City of Sumner **DESIGN COMMISSION**

REPORT TO THE DESIGN COMMISSION
from the DEVELOPMENT SERVICES DEPARTMENT

Permit Number: DR-2021-0044

Project Components: Design Review for the development of a 60-unit apartment project phase II of the East Sumner Apartments, on a 2-acre site at the East corner of 162nd Ave E and 60th Street consisting of three 3-story buildings with associated on-site parking and common open/recreation space within the high-density residential zone (HDR).

Preliminary Site Plan

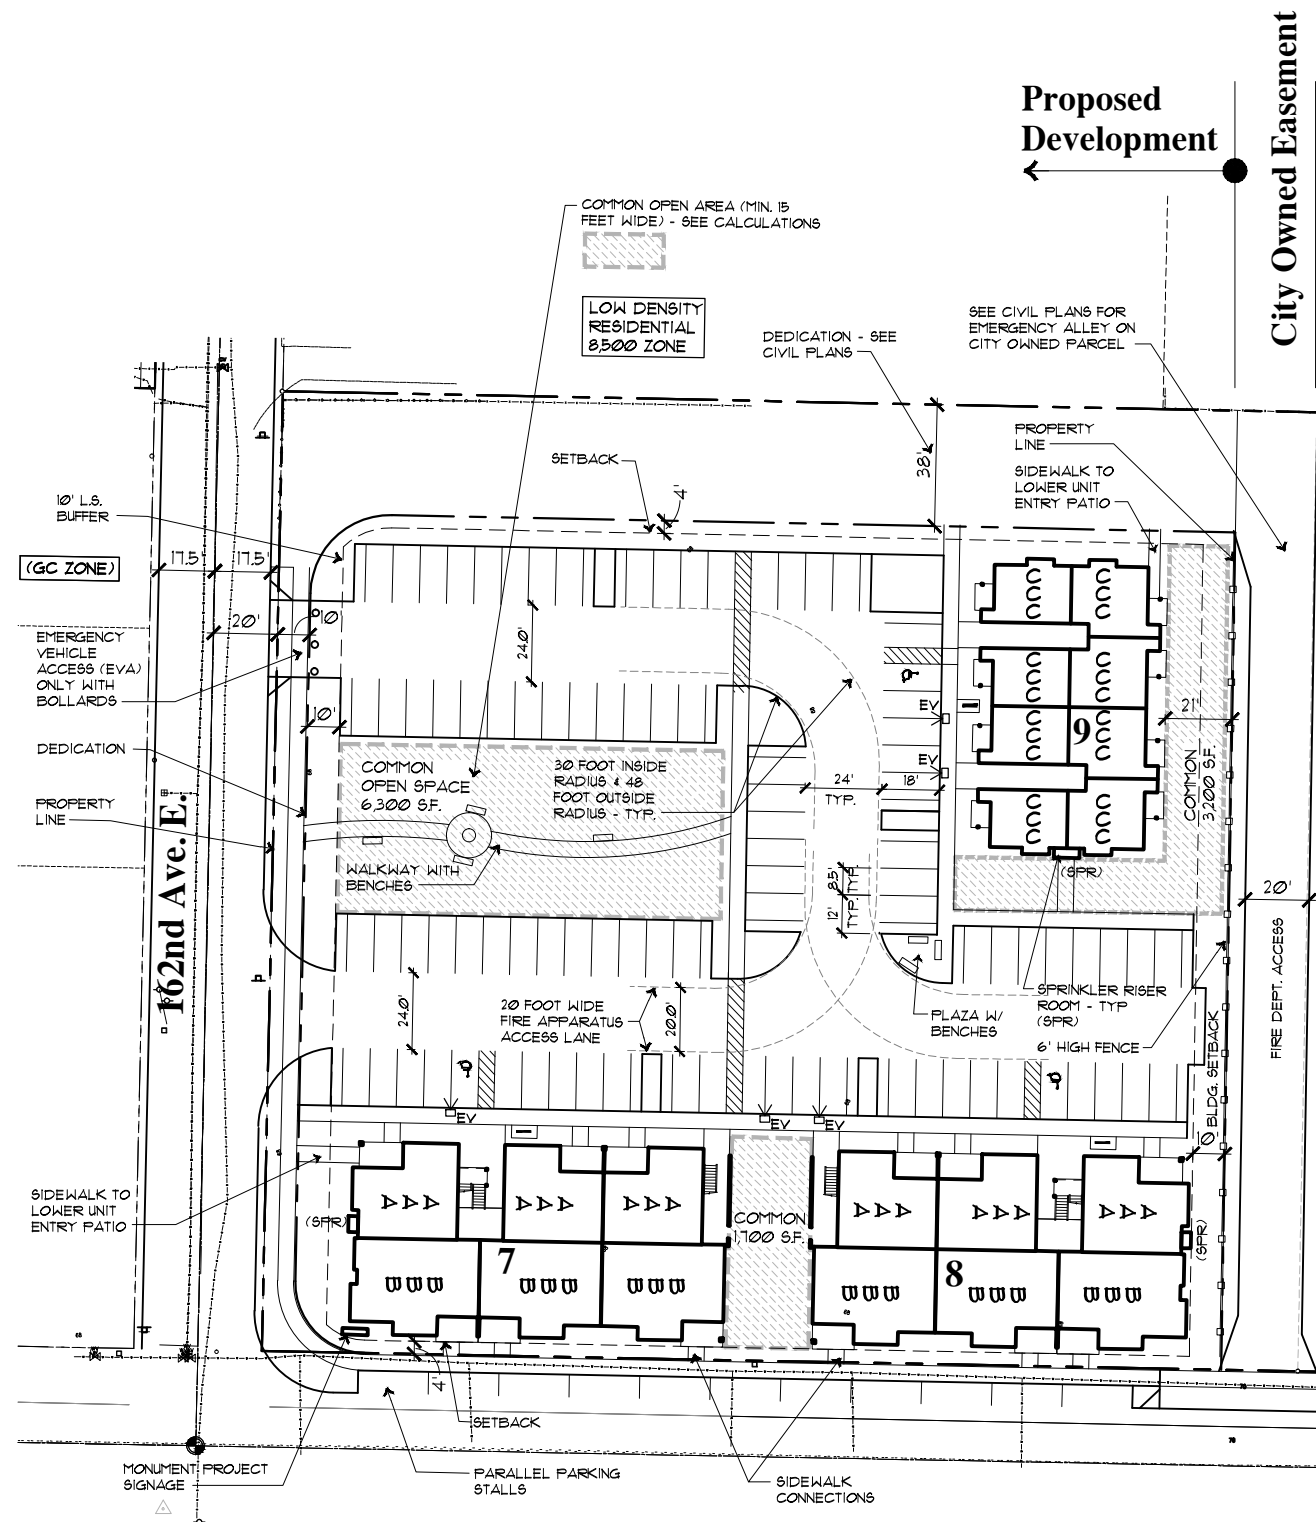
These common areas would need additional pedestrian amenities to serve as a common space. The total number of onsite parking is met, providing 91 stalls to include 12 guest parking spaces. The site is shown to propose 11 parallel street parking spaces along 60th street which is not counted towards the onsite parking calculation. Per the dimensional standards for Apartments under this guideline, this proposal complies with current setback requirements per the Design Guidelines; the tallest multifamily building is proposed between 30-40 feet. The proposed density is 35 dwelling units per acre (ESUV allows = 40 du/ac), for a total of 60 units on 1.73 net acres. Provided this site meets all other open space

This project will construct 38 feet of a new street to connect 164th Ace Ct E over to 162nd Ave. With the new street layout, the site is bound by 3 public streets and the location of parking was determined through access and fire turnaround requirements. Parking on this site is shown to be centered, with building 7 & 8 fronting along 60th street, the parking locations are presented behind the building. However, the corner of the new street and 162nd Ave E presents a conflict with this guideline. Discussions with the applicant to consider an alternative site layout resulted in minor site changes. A new driveway access will now come off the new constructed street, allowing full landscape screening of the parking areas above the common open space. The location of this new drive aisle will allow for better traffic flow and further conditions will require a landscape feature and/or structure to create a presence at the common open space. Staff feels that this site

*The common open space area of 1,700 square feet is located between buildings 7 & 8 featuring 2-3 large maple trees in an open grassy area. This is a part of a side yard area between the stair side elevations, and a two-part condition will require low-level fencing to separate private patio entrances from common open spaces and landscaping shrubs will be planted along ground floor unit windows. **This condition will be listed as sub-condition b) under this guideline.***

The rear yard and side yard of building 9, housing studio apartment dwelling units, are proposed as common open space of 3,200 square feet, featuring 5 large Japanese styrax trees planted in the rear yard, approximately 21 feet wide. A 6-foot-tall fence is proposed along the east property line, adjacent to the 20-foot-wide access. As a condition, separation of private ground floor entrances and landscaping shrubs along ground floor unit windows will also apply to building 9 as conditioned above. The side yard along building 9 should be constructed

- a) The screening at the base of the main stairwell entrances shall include landscaped planters and open seating under a roofed canopy. The use of metal gated screening here is not recommended.
 - i. If a metal gated screening is desired, the metal screening material shall be a decorative pattern, the height of the screening should be no taller than 9 feet, and the doorway should be required to maintain a 6-foot width.
- b) The landing decks above the stairwells should remain an open feel, by installing partial metal decorative screening, or framing in the area.
- c) Staff recommends that the screening of the secondary stairwells and the stairwell entrances on Building 9, should include adding architectural features to and or above the entrance by

- a) All 5-foot-wide pedestrian crosswalks crossing the drive aisles shall be paved with colored and stamped concrete.
 - i. Add a crosswalk from building 8 to the plaza benches area.
- b) The walkway within the common open space shall be paved with a scored concrete of contrasting tones. This walkway through the common open space area shall remain curved as proposed.
- c) The paved plaza as recommended in the common open space shall be paved with scored concrete of contrasting tones. The use of pavers would be acceptable.
- d) To strengthen pedestrian connection, the parking area and drive aisle located between Building 9 and the main common open space shall be paved with colored and stamped pattern concrete of contrasting colors.

- a) Common open space areas shall be buffered from parking areas. Along the edge of the common open space, landscape plans shall show adequate low shrub plantings as a parking buffer.
- b) Within the pedestrian common open space area, there should be a paved plaza area under the picnic areas. The paved plaza area shall be large enough to provide functional leisure and recreational activity and accommodate a covered structure.
- c) A landscaped plaza entrance of the common open space located along 162nd shall be designed as an attractive feature to provide separation of public and private space, and functions to provide seating.
- d) Install low-level fencing to separate private patio entrances from common open spaces and plant large landscaping shrubs along all ground floor unit windows that face a common open space.

Title:
**LANDSCAPE PLAN
EAST BUILDINGS
FOR
EAST SUMNER APARTMENT COMPLEX**

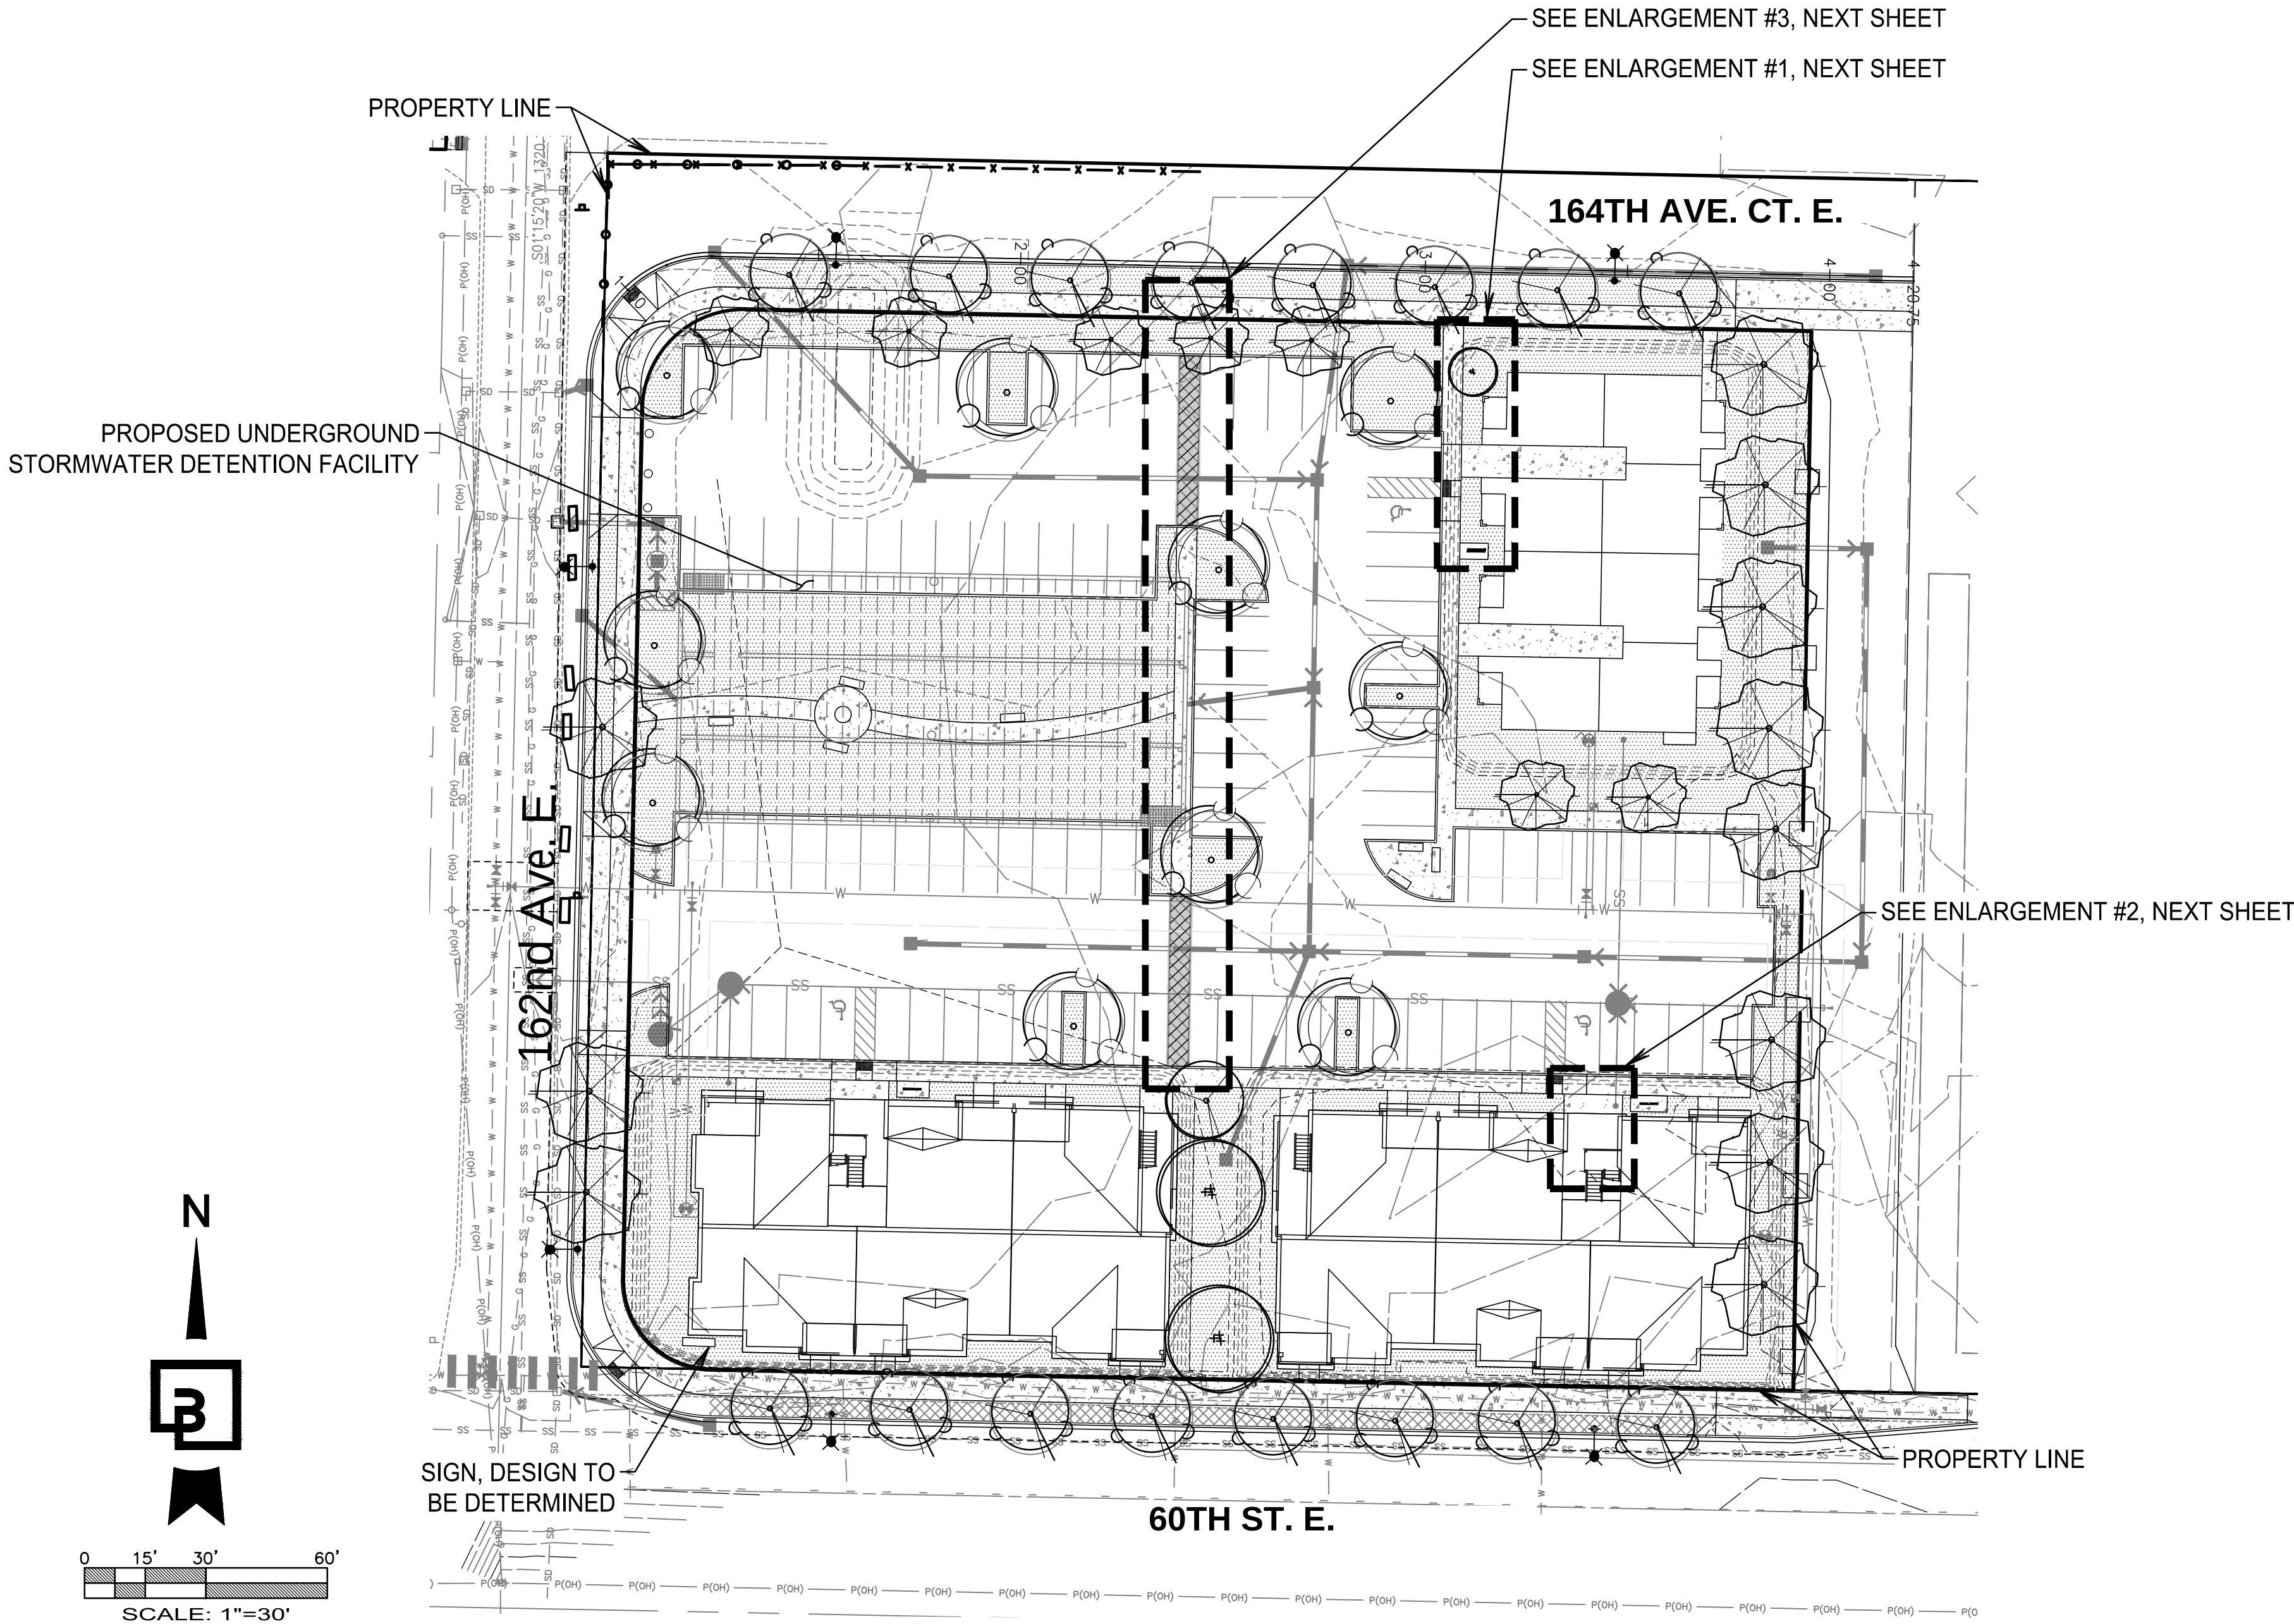
At time of development permit the general site layout as shown on the Design Review Site Plan shall be used and the landscape plan shall be modified and enhanced to maintain consistency and meet SMC 18.41. As a standard condition, this guideline is satisfied.

At time of development permit the general site layout as shown on the Design Review Site Plan shall be used and the landscape plans shall be modified and enhanced to maintain consistency with landscaping guidelines and meet SMC 18.41.

Building 7 - Side Elevation
SCALE: 1/8"=1'-0"

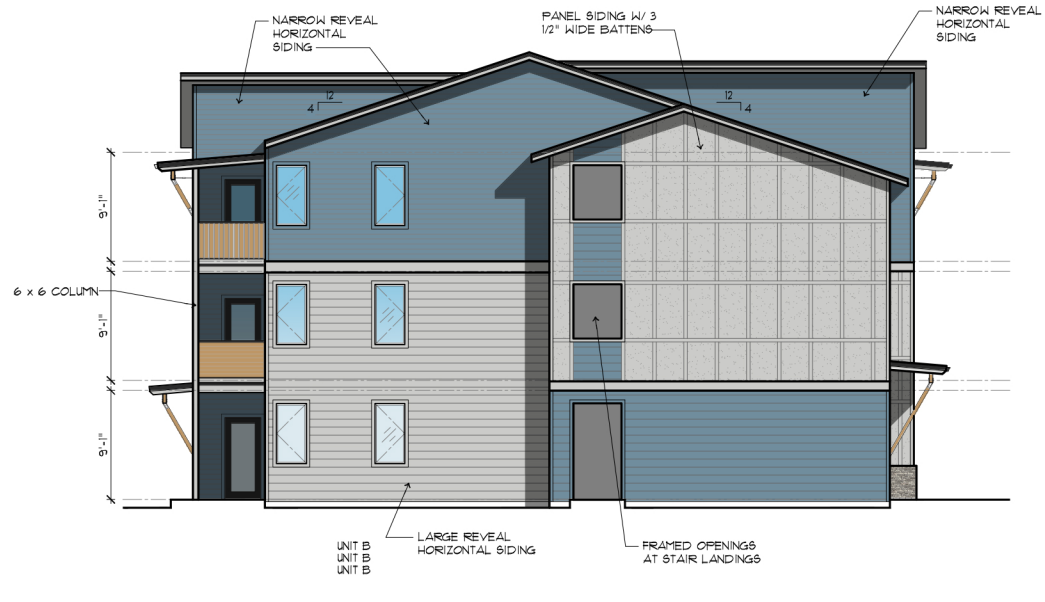
The Side Elevation provides variety by changing rooflines; however repetition of variety should reflect along both side elevations. Color changes alone does not provide the intended variety.

Building 8 - Stair Side Elevation

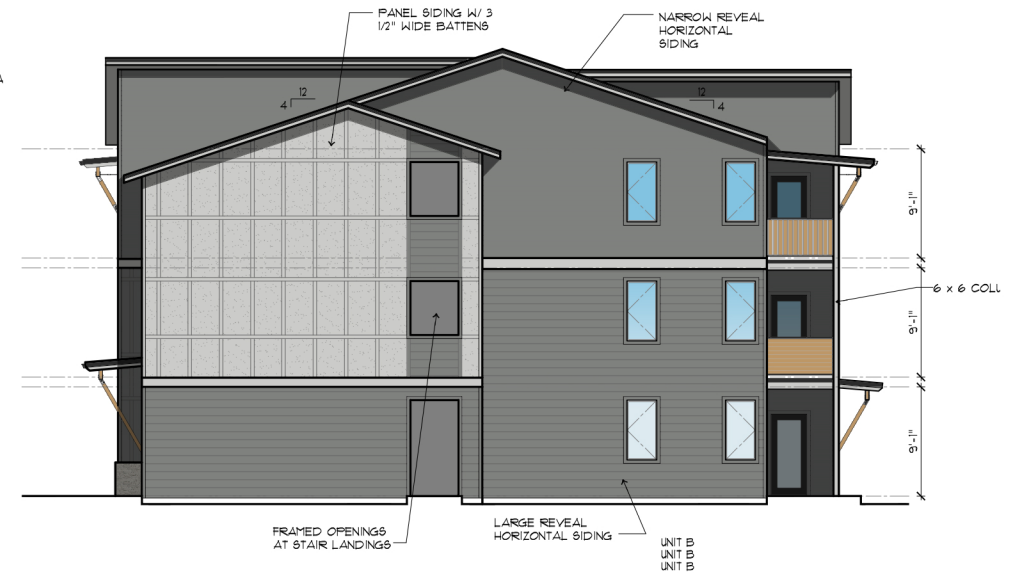
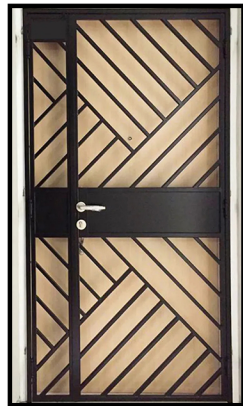
Proposing full metal screening across the entire entrance of the main stairwell present conflicts with the overall design and efficiency of the space. Staff approves of the applicant's design of the recessed entryway, adding a landscaping planter above and behind the bench at the base of the stairwell. Requiring the metal screening here, limits the space for comfortable seating and would hide any landscaping. Eliminating the lower area from full screening requirements, will help to diminish the caged and industrial effects of the metal screening. Staff feels that keeping an open amenity space here and adding landscaping adequately serves as a partial screening while providing function. Screening with landscaping planters and a bench/seating area at the base of the main stairwell on buildings 7 & 8, should be considered as adequate. Because these stairwells turn internal, the screening efforts with landscaping and maintaining a seating area is favorable over gated screening. **As sub-condition a) the screening of the base of the main stairwell entrances should just include landscaping and open seating under a roofed canopy.** The use of metal gated screening here is not recommended.

The metal screening attached above the landing decks is comprised of 2"x4" square mesh material. This differs from the decorative pattern proposed on the gate door. The use of the black mesh material above the landing decks adequately screens and discussions with applicant determined that the mesh screening would be setback into the stairwell and not as visible from the outside. Staff is in favor of a more decorative pattern, but any mesh or metal screening material used above the stairwells should be considered in moderation, or partial installation. Staff feels that the metal screening should have a wider reveal and a decorative pattern and supports a partial screening. **As sub-condition b), staff recommends that the landing deck remain an open feel, by installing partial screening or framing in the area.**

The Side Elevation provides variety by changing rooflines, however repetition of variety should reflect along both side elevations. Particularly, the interior side elevations. Building modulation at the pedestrian scale needs to be considered. Color changes alone does not provide the intended variety,
